Name: Trolley Park Subdivision in C-2 Zone - Final Plan

REVIEW COMMENTS

FILE NO. #54-92 **TITLE HEADING: Final Plan/Plat**

ACTIVITY: Trolley Park

UTILITY COMPOSITE AND LANDSCAPING PLANS
TROLLEY PARK
 GRAND JUNCTION, COLORADO
W.H. LIZER & ASSOCIATES
 ENGINEERING & SURVEYING
 576 25 ROAD UNIT 8 241-1128
 GRAND JUNCTION, COLORADO 81505

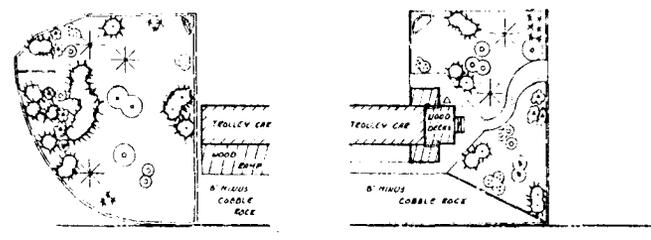
1. The existing sign is in the additional ROW area. It must be moved out or be reduced to 30" maximum height.
2. Provide a manhole at the "tee" of sewer services.

SEWER - Second manhole on east/west line to be placed at junction of 6" and 4" lines; not at end of 4" line as shown. Sewer services should not be installed with 90° bands as shown.
WATER - Water line is shown under proposed valley pan. I don't believe this is acceptable to Ute Water.

1. Sewer - The manhole has been moved to the end of the existing 6" sewer line as requested.
2. Water - The street has been widened to allow placing the Ute Water line under the pavement rather than under the concrete pan.
3. Drainage - All required easements have been added to the final plat.

TROLLEY PARK
 A PART OF THE
 SW 1/4 NW 1/4 & NW 1/4 SW 1/4
 SECTION 10, T.1S. R.1W., UTE MERIDIAN
 GRAND JUNCTION, MESA COUNTY, COLORADO

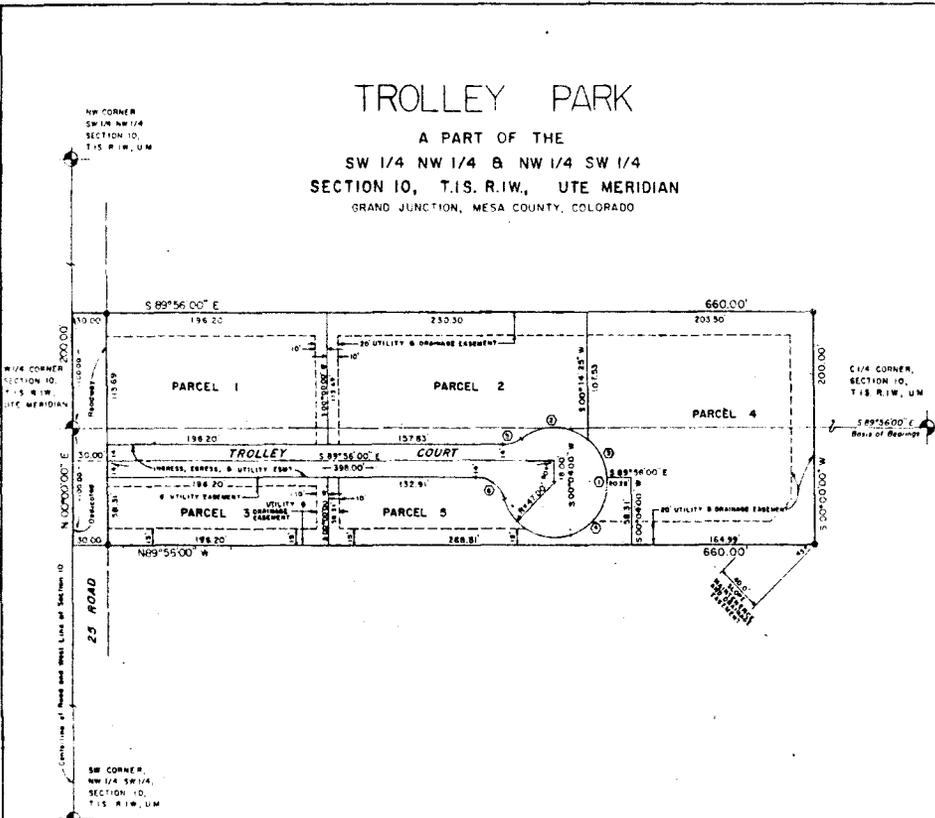
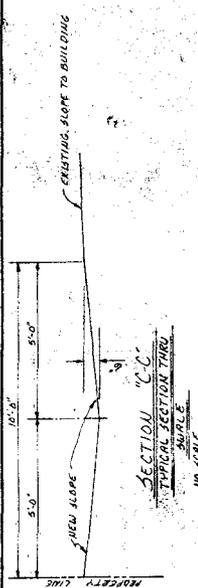
1. Provide all utility easements, remove drainage easements, and provide full information on the slope maintenance easement and common tract.
2. Add a note which prohibits access to lots from 25 Road except at the designated common tract.
3. The common tract should be dedicated to the owners of lots created by the plat for ingress, egress, drainage, and parking, and also to the City on behalf of public utilities for utility installation and maintenance.

1. The plat shows tracts and identifies them as easements, does not define between existing and proposed easements and existing and proposed right-of-way, and does not provide the 40' required 1/2 street right-of-way for 25 Road.
2. Utilities are shown which are not in an easement.
3. The completed street plan and profile was not received until 9/4/92, and a grading and drainage plan and report was not even submitted until then. The drainage report is incomplete, does not address criteria, and is unacceptable. Consequently, drainage and street facilities are unacceptable.

1. The final plat dedicates all easements shown. Ten feet has been added to 25 Road right-of-way.

2. All utilities have had easements provided for them.
3. Attached are the revised street and drainage plans and your review comments on same.

GRADING AND DRAINAGE PLANS
TROLLEY PARK
GRAND JUNCTION, COLORADO
#5 A, 92

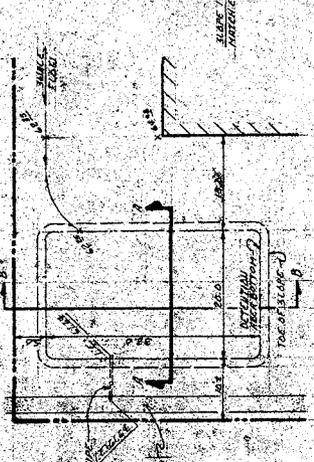
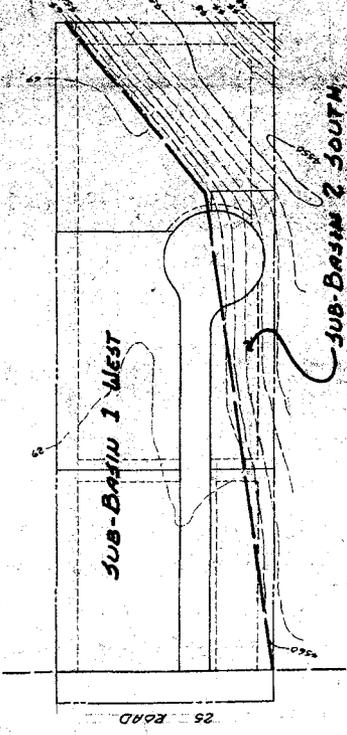
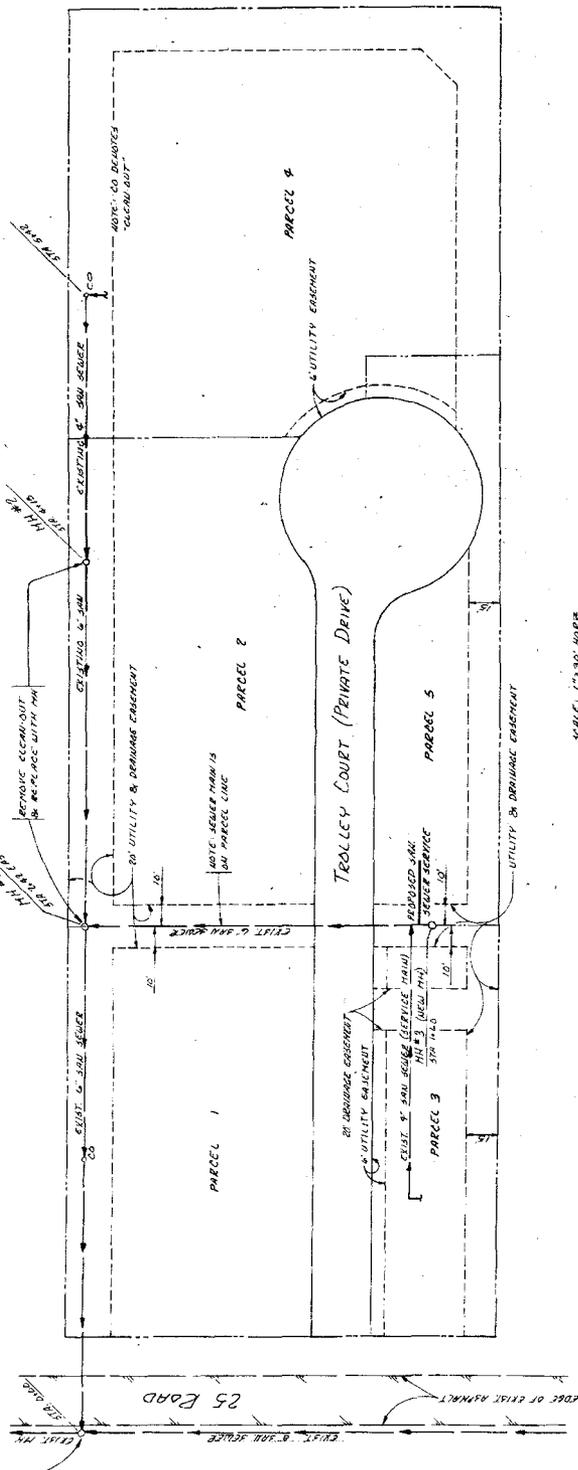
Revise to show changed conditions and requirements.

For the most part, items (i), (ii), and (iii) were addressed. However upon review of the grading and drainage plan and drainage report, it was apparent that previous comments regarding them were mostly ignored or misunderstood. The following red-lined comments were provided on the September submittal plan and report.

calculations were provided, and it is questionable whether the on-grade capacity is adequate for the 100-year event. Criteria indicates that collection/conveyance systems need only be designed for the 2-year event, but in this case, failure to design for the 100-year event (inlet and pipe system) will result in inlet flow-by to sub-basin #2, which is already by waiver allowed a 47% increase over historic flow to 25 Road. Design the inlet per the criteria manual for the 100-year runoff event, and provide calculations.

The water from Sub-base 3 will be intercepted by a drop inlet in the valley pan. No storm water will go to the South as sheet flow.

PLATE (SINGLE MAIN AND PROFILE FULL LINE)

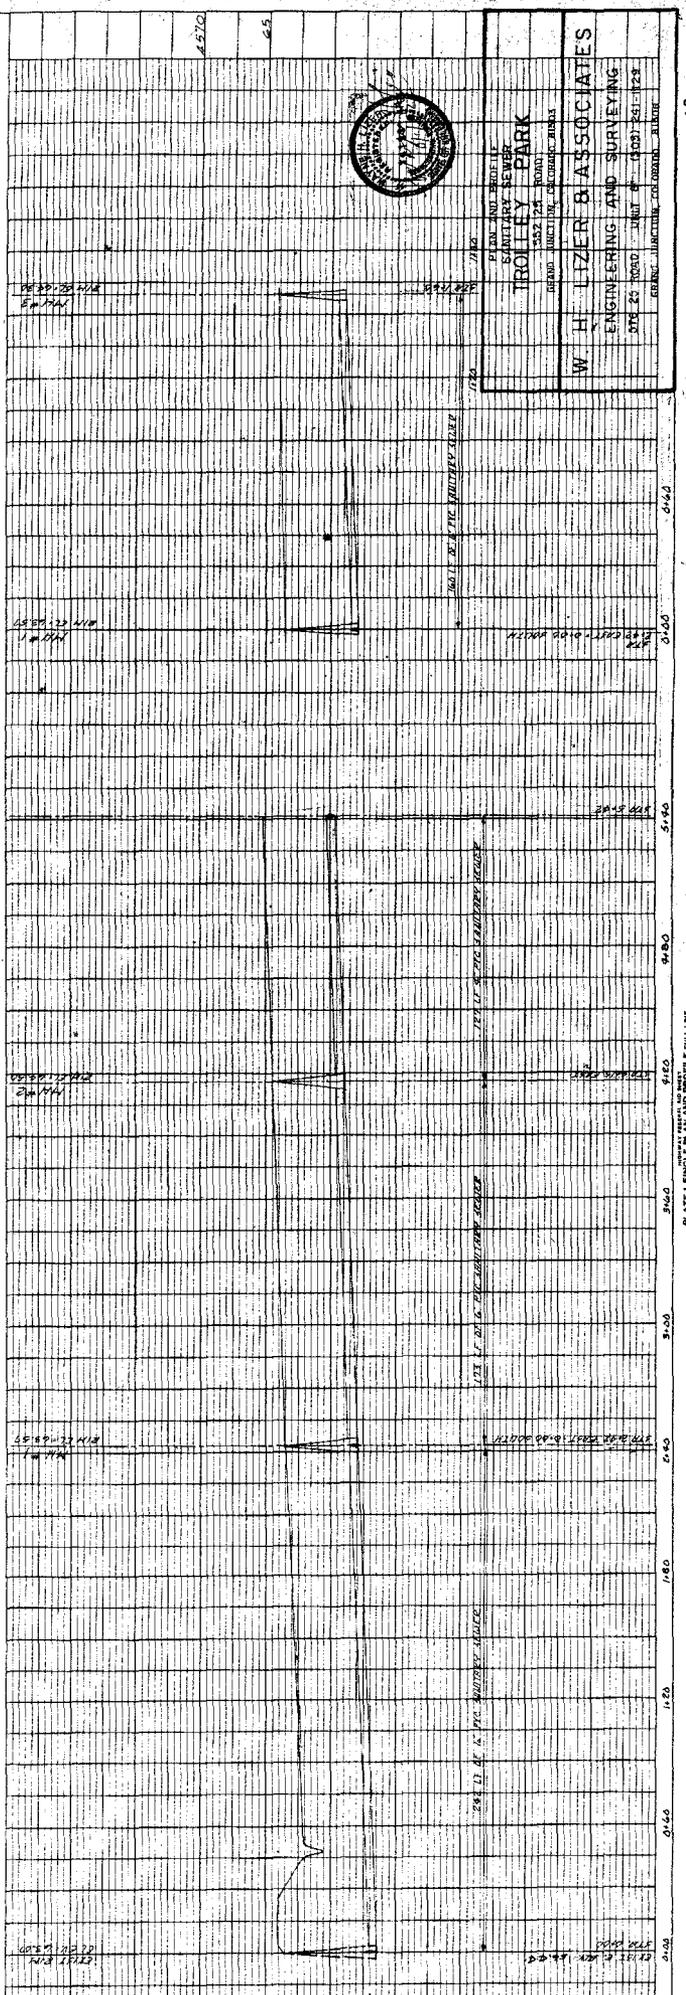
Not necessary.
